Wisconsin Department of Transportation

Proposal #26: 6320-08-62, WISC 2018 448
Plainfield – Wisconsin Rapids
Bridge Maintenance B-71-0018
STH 73
Wood County

9260-01-61, WISC 2018 450
Crandon – Three Lakes
Bridge Maintenance B-21-0015
STH 32
Forest County

This is Addendum No. 01, which provides for the following:

Addendum No. 01
 ID 9260-01-61
 Revised Sheet 64
 November 9, 2018

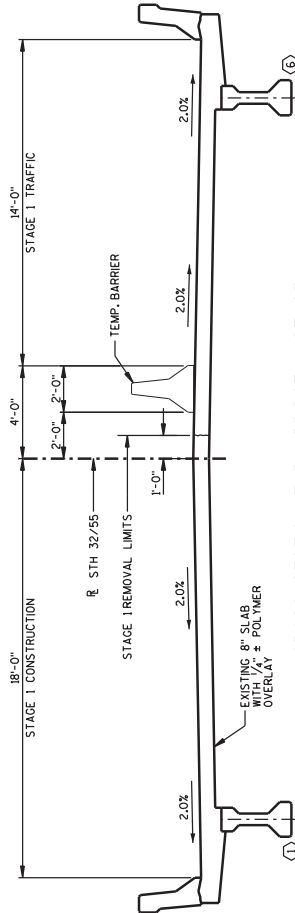
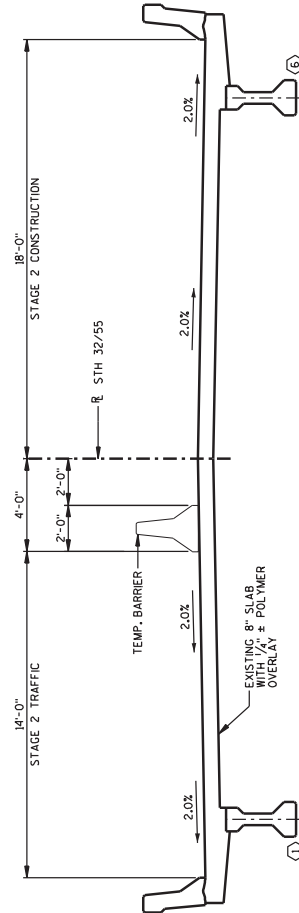
Revised Plan Sheets	
Plan Sheet	Plan Sheet Title (brief description of changes to sheet)
64	Structure Quantities Table (Added: Adhesive Anchors No. 5 Bars & Concrete Masonry Overlay Decks)

ITEM NUMBER	BID ITEM	UNIT	WEST ABUT.	PIER 1	PIER 2	EAST ABUT.	SUPER	TOTAL
203.02.25.03	DEBRIS CONTAINMENT B-21-15	LS	-	-	-	-	-	1
502.3100.03	EXPANSION DEVICE B-21-15	LS	-	-	-	-	-	1
502.3210	PIGMENTED SURFACE SEALER	SY	-	-	-	-	-	190
502.4205	ADHESIVE ANCHORS NO. 5 BAR	EACH	-	-	-	-	-	112
505.0600	BAR STEEL REINFORCEMENT HS COATED STRUCTURES	LB	-	-	-	-	-	4420
505.0904	BAR COUPLERS NO. 4	EACH	-	-	-	-	-	6
505.0905	BAR COUPLERS NO. 5	EACH	-	-	-	-	-	6
505.0906	BAR COUPLERS NO. 6	EACH	-	-	-	-	-	24
505.0907	BAR COUPLERS NO. 7	EACH	-	-	-	-	-	12
509.1000	JOINT REPAIR	SF	-	-	-	-	-	49
509.1500	CONCRETE SURFACE REPAIR	SF	20	-	-	10	-	40
509.2500	CONCRETE MASONRY OVERLAY DECKS	CY	-	-	-	-	-	17
509.5100.S	POLYMER OVERLAY	SY	-	-	-	-	-	50
